# UNITED STATES PATENT AND TRADEMARK OFFICE

# Office Action Summary

10/511,461

## **DETAILED ACTION**

Figure 1 from Hunt US Patent 1,850,878

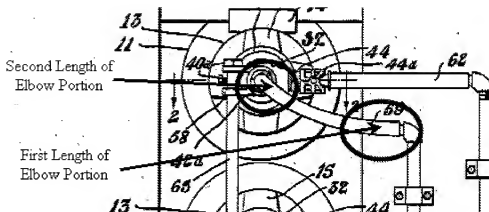
With regards to claim 30, Hunt discloses an arrangement for cooling a roll, the arrangement comprising: a housing (32) to be secured to the roll (11), the housing mounted for rotation about a hollow shaft (48), the shaft having a length and a longitudinal axis, and an elongate cooling medium line conduit (45) extending into the roll to convey cooling medium into the roll via the interior of the shaft, the external surface of the elongate cooling medium line conduit and an internal surface of the shaft defining a cooling medium flowpath out of the roll [Page 2, lines 105-125],

the elongate cooling medium line conduit connected to an elbow portion (59), a first length of the elbow portion extending from the inlet or outlet substantially perpendicular to the longitudinal axis of the shaft and a second length of the elbow portion extending from the first length in the longitudinal direction of the axis of the shaft [see attached Figures 1 and 2 on page 6 of this Office Action], wherein the elongate cooling medium line conduit and elbow portion remain stationary as the housing rotates [Page 3, lines 43-48].

With regards to claim 32, Hunt discloses the first cooling medium line conduit (45) to convey cooling medium into the roll (11) via the interior of the shaft, the first cooling medium line comprising an inlet (42) communicating with a first elbow portion, a first length of the first elbow portion extending from the inlet substantially perpendicular to the longitudinal axis of the shaft and a second length of the first elbow portion extending from the first length in the

direction of the longitudinal axis of the shaft, the axes of the first and second lengths being in substantially the same plane [see attached Figures 1 and 2 on page 6 of this Office Action]; and (ii) a second cooling medium line to convey cooling medium out of the roll via the interior of the shaft, the second cooling medium line (48) comprising a flow path, including conveying cooling medium between the outer surface of the first cooling medium line and the internal wall of the shaft to an outlet (44) [Page 2, lines 105-125].

With regards to claim 33, Hunt discloses wherein the internal wall of the elbow portion has a bend radius between the first length and the second length, as seen in Figure 1.

Figure 2 from Hunt US Patent 1,850,878

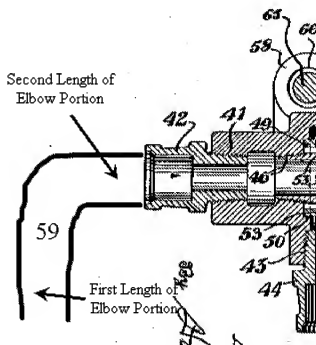
With regards to claim 42, Hunt discloses wherein the cooling medium line is substantially cylindrical, as seen in Figure 2.

With regards to claim 46, Hunt discloses including a delivery flow path that delivers cooling medium into the roll via the interior of the shaft and a return flow path for outflow of cooling medium via the interior of the shaft [Page 2, lines 105-125 and Figure 2].
